Evanston Ecology Center Renovation

BID # 23-55

ADDENDUM No. 04

This addendum forms a part of the Bid documents for Bid # 23-55 and modifies these documents. This addendum consists of the following:

CP6000 AC Commercial Station Specifications

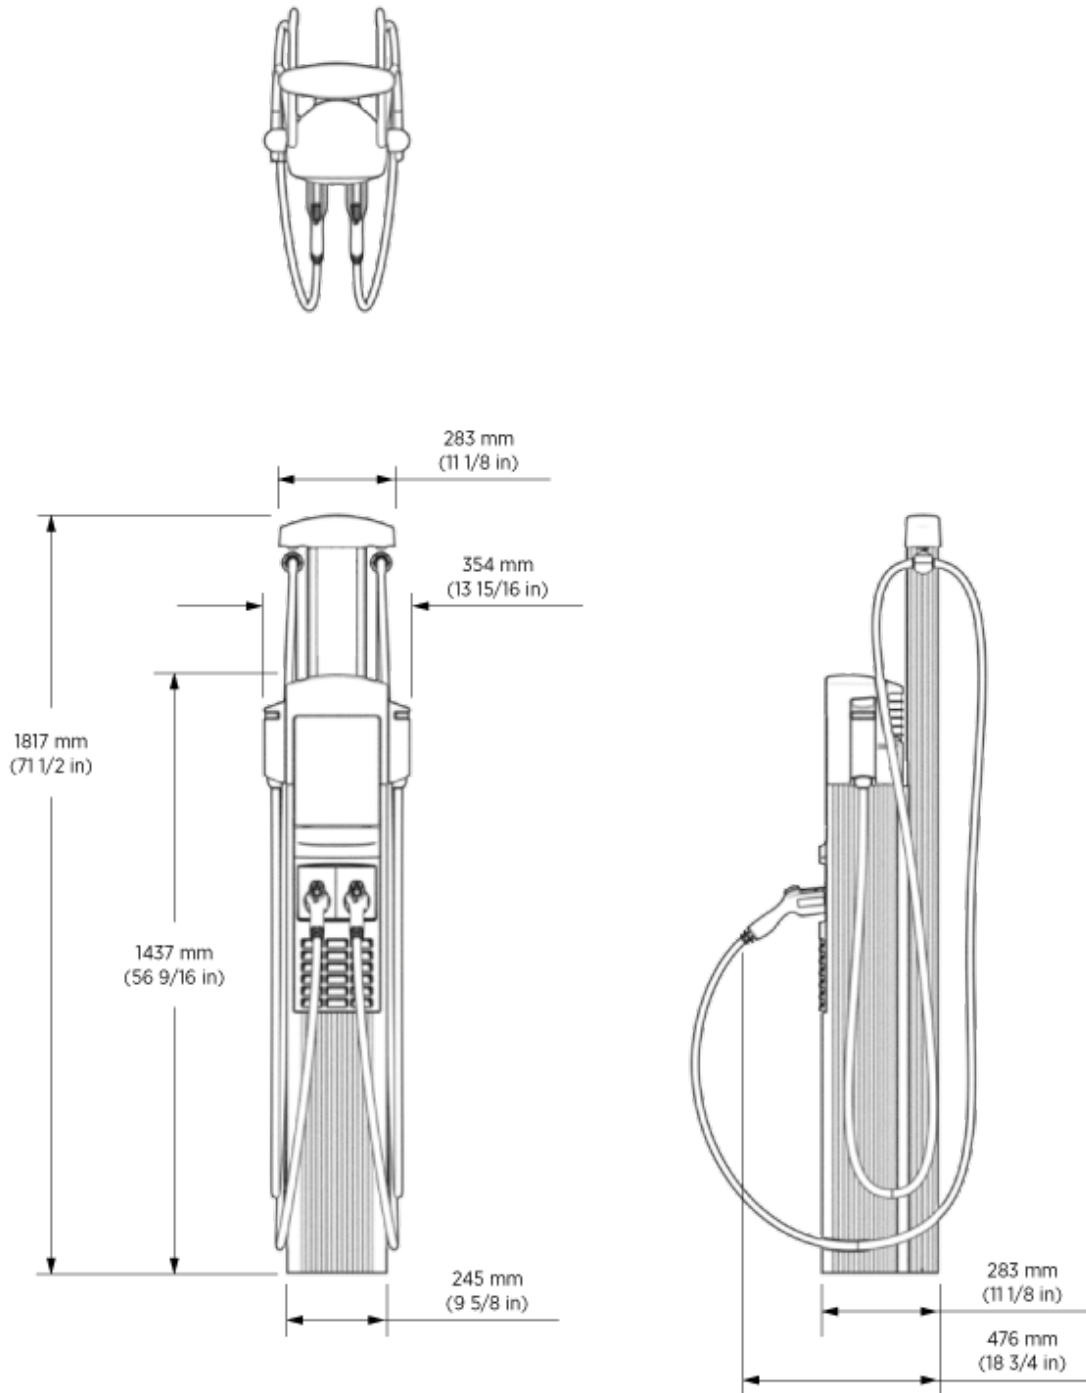
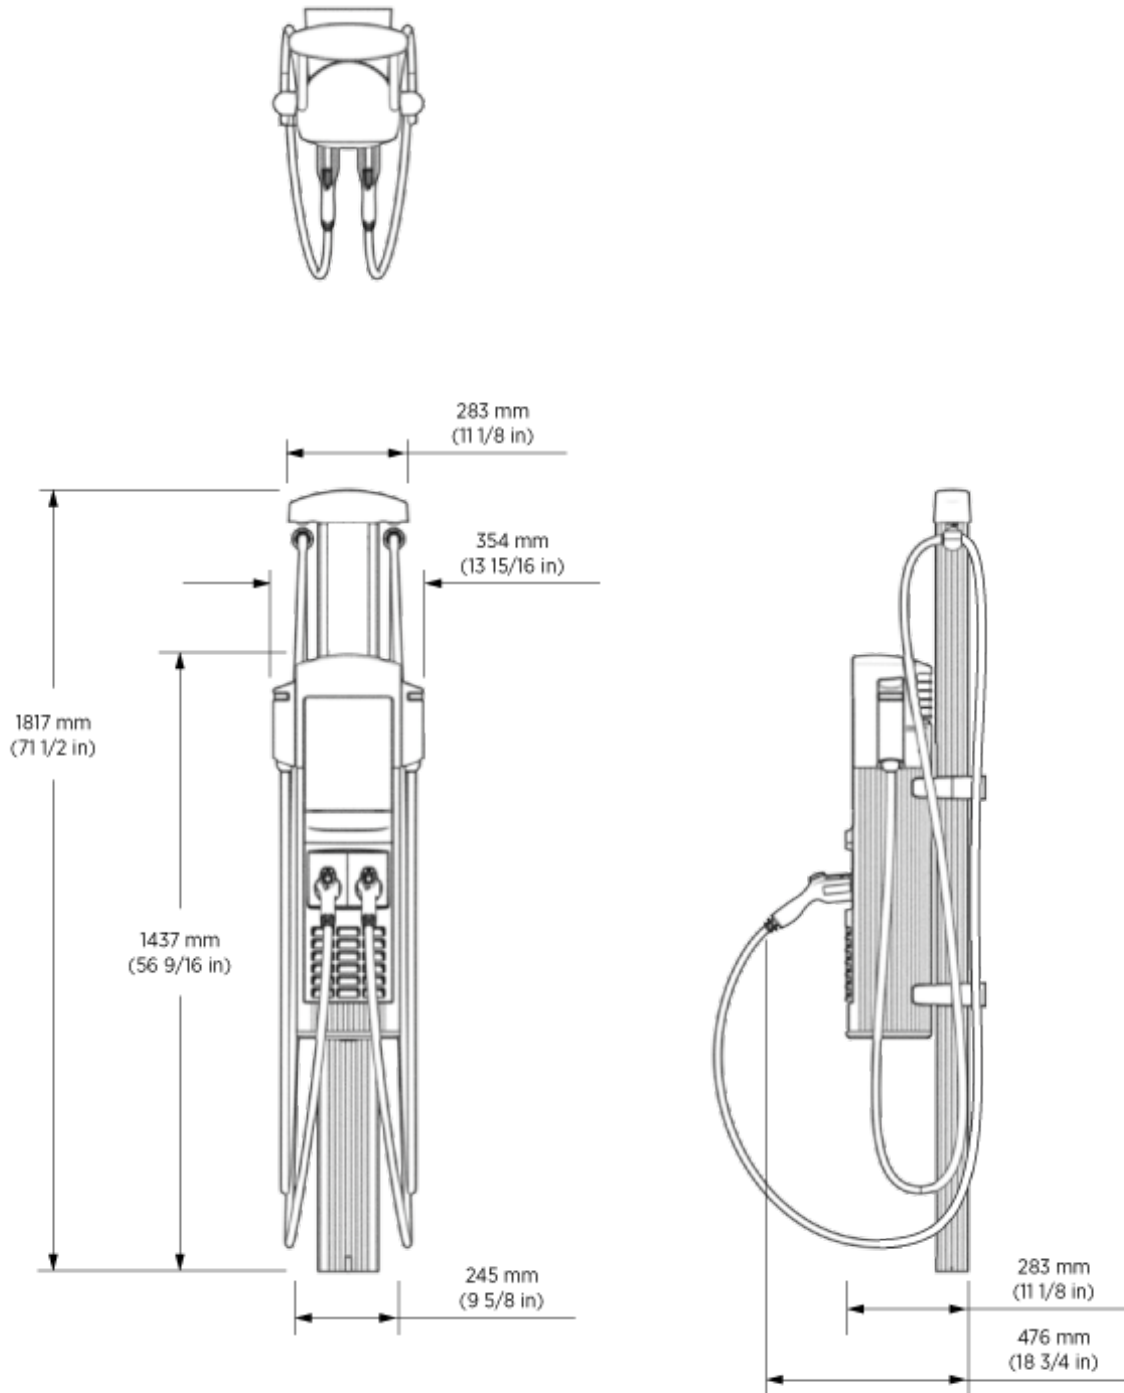
30. **Question:** Drawing E100 indicates two (2) EV Charging Stations. We do not see a specification for the charging stations. Who is providing the charging stations? If the charging stations are to be provided by the electrical subcontractor can a specification be provided?

Response: ChargePoint CP6000 Series (1) single port charger and (1) dual port charger
